<p>TO: Mercedes-Benz Dealer Principals, General Managers, Sales Managers, Service Managers, Parts Managers</p>	<p>FROM: Anthony Washington, Department Manager, Regulations and Certifications</p>
<p>Re: Service Campaign Launch Notification Model 447 (Metris) Model Year 2021 Retrofit HERMES Module</p>	<p>DATE: May, 2022</p>

Campaign No. 2022040004 May, 2022

SUBJECT: **Model 447 Model Year 2021
Retrofit HERMES Module**

S82.95-A015-79

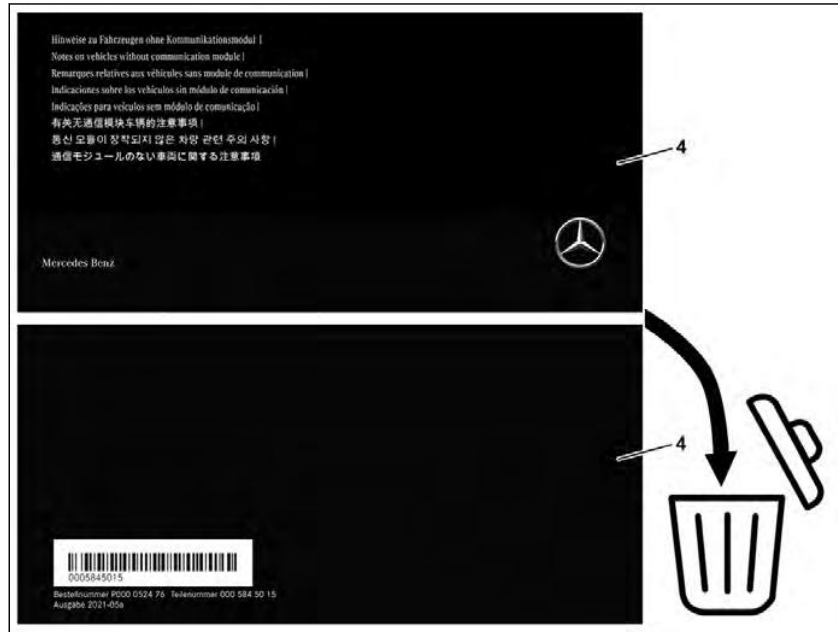
5	Disconnect electrical connectors (1).		
6	Release front and rear lock on holder (2) and remove dummy control unit to one side.	<p> Dispose of removed dummy control unit properly. Observe the applicable legal requirements and specifications of the relevant country.</p>	
	Install		
7	Install new HERMES control unit (N112/9) on holder (2) and lock.		
8	Connect electrical connectors (1).
